UNITED STATES PATENT AND TRADEMARK OFFICE

APPLICATION NO.	FILING DATE	FIRST NAMED INVENTOR	ATTORNEY DOCKET NO.	CONFIRMATION NO.
09/537,274	03/29/2000	Larry Eugene Mosley	884.240US1	7167

Office Action Summary

DETAILED ACTION**Introduction:**

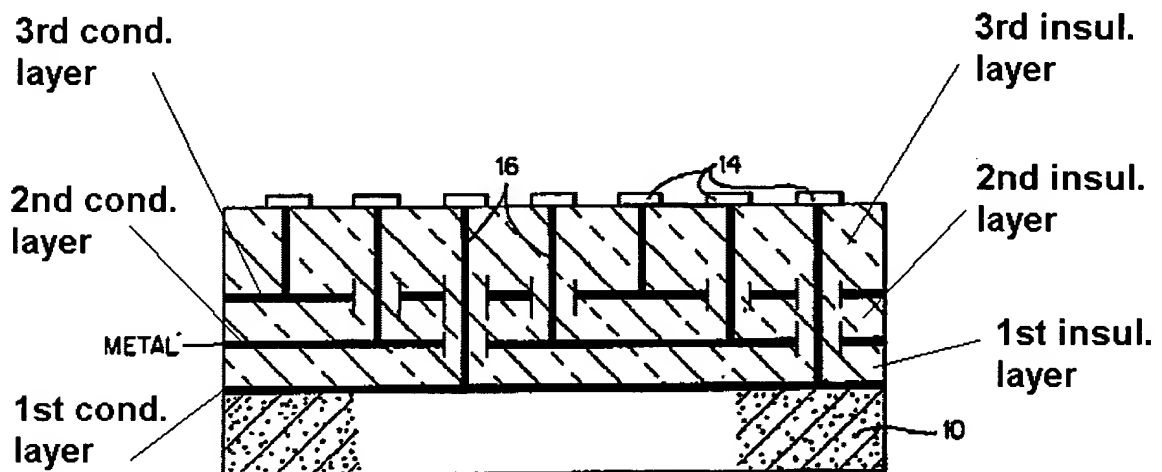
2. Claims 1, 8, 11 are rejected under 35 U.S.C. 102(b) as being anticipated by IBM

'3117 discloses a multi layer integrated circuit capacitor comprising: a substrate (10); a first conductive layer located over and contacting the substrate (see above);

a first insulator layer located over and contacting the first conductive layer, the first insulator layer not contacting the substrate; a second conductive layer located over the first insulator layer; a second insulator layer located over the second conductive layer; a third conductive layer located over the second insulator layer; a third insulator layer located over the third conductor layer; and a plurality of conductive vias (16) downwardly extending through the third insulator layer to provide electrical interconnection to the first, second and third conductive layers.

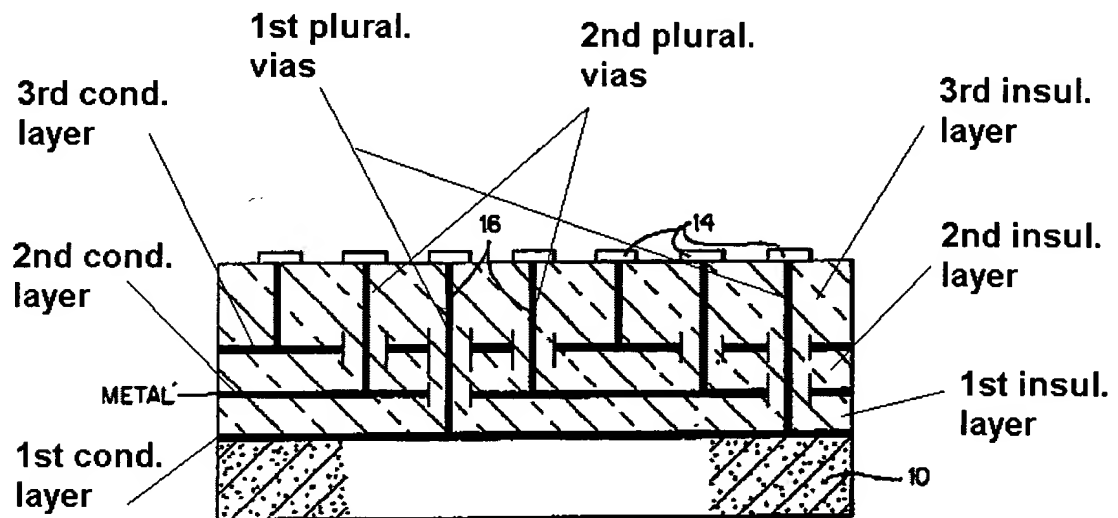
Regarding claim 8, '3117 discloses some of the plurality of conductive vias pass through the second conductive layer without forming an electrical connection with the second conductive layer (see above fig).

Regarding claim 11, '3117 disclose a multi layer integrated circuit capacitor comprising: a substrate (10); a first conductive layer located over and contacting the

substrate; a first insulator layer located over and contacting the first conductive layer, the first insulator layer not contacting the substrate; a second conductive layer located over the first insulator layer, the second conductive layer being fabricated as a plurality of laterally spaced strips such that a surface area of the second conductive layer is less than a surface area of the first conductive layer; a second insulator layer located over the second conductive layer; a third conductive layer located over the second insulator layer, the third conductive layer being fabricated as a plurality of laterally spaced strips such that a surface area of the third conductive layer is less than the surface area of the second conductive layer; a third insulator layer located over the third conductive layer; a first plurality of conductive vias (16) downwardly extending through the third insulator layer to provide electrical interconnection to the third conductive layer; a second plurality of conductive vias (16) downwardly extending through the third insulator layer to provide electrical interconnection to the second conductive layer; and a third plurality of conductive vias downwardly extending through the third insulator layer to provide electrical interconnection to the first conductive layer (SEE ABOVE).

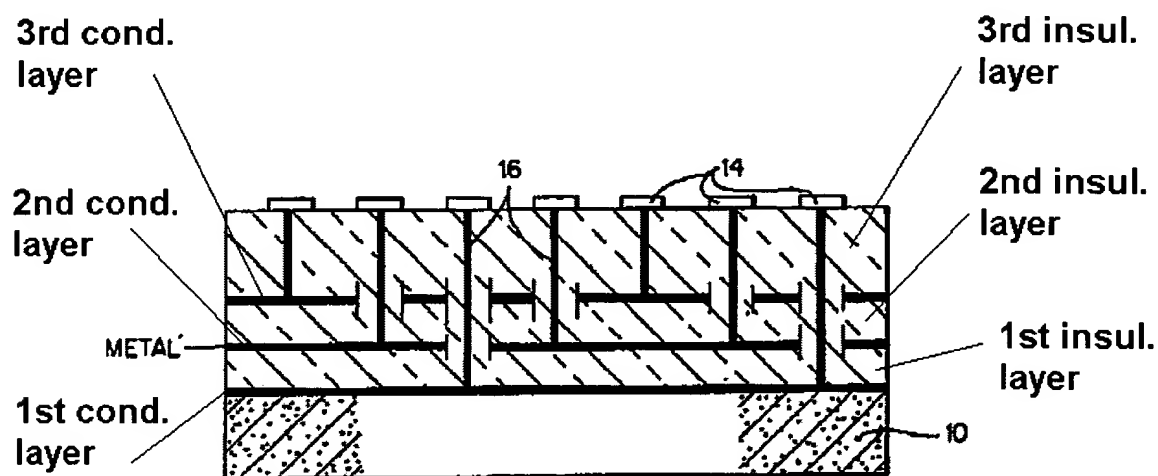
4. Claims 4-5, 13, 19, 21 are rejected under 35 U.S.C. 103(a) as being unpatentable over IBM Technical disclosure bulletin (Cross-reference 0018-8689-20-8-3117 – Referred as '3117).

Regarding claim 4, '3117 discloses the claimed invention except for the insulator layers are formed from a BaSrTiO₃ material. It is well known in the capacitor art to form insulating layers from a BaSrTiO₃ material (excellent dielectric properties). It would have been obvious to one having ordinary skill in the art at the time the invention was made to form the dielectric from a BaSrTiO₃, since it has been held to be within the general skill of a worker in the art to select a known material on the basis of its suitability for the intended use as a matter of obvious design choice. In re Leshin, 125 USPQ 416.

Regarding claim 5, '3117 discloses the claimed invention for the conductive layers are formed from copper. It is well know in the capacitor art to form conductive layers (electrodes) from a copper material (excellent conductive properties). It would have been obvious to one having ordinary skill in the art at the time the invention was made to form the conductive layers from a copper material, since it has been held to be within the general skill of a worker in the art to select a known material on the basis of its suitability for the intended use as a matter of obvious design choice. In re Leshin, 125 USPQ 416.

Regarding claim 13, '3117 discloses the claimed invention except for the insulator layers are formed from a BaSrTiO₃ material. It is well known in the capacitor art to form insulating layers from a BaSrTiO₃ material (excellent dielectric properties). It would have been obvious to one having ordinary skill in the art at the time the invention

Regarding claim 19, '3117 discloses a multi layer integrated circuit capacitor comprising: a substrate (10); a first conductive layer located over and contacting the substrate (see above); a first insulator layer located over and contacting the first conductive layer, the first insulator layer not contacting the substrate; a second conductive layer located over the first insulator layer; a second insulator layer located over the second conductive layer; a third conductive layer located over the second insulator layer; a third insulator layer located over the third conductor layer; and a plurality of conductive vias (16) downwardly extending through the third insulator layer to provide electrical interconnection to the first, second and third conductive layers.

'3117 discloses the claimed invention except for the plurality of vias extending through the substrate to provide electrical interconnection to both a top surface and a bottom surface of the integrated circuit capacitor. It is well known in the capacitor art to extend vias through a substrate to provide electrical interconnections to both sides of the capacitive element. It would have been obvious to a person of ordinary skill in the art at the time the invention was made to extend the vias of '3117 through the substrate to provide electrical interconnections to both sides of the capacitor, since such a modification would decrease the space needed in the electrical system.
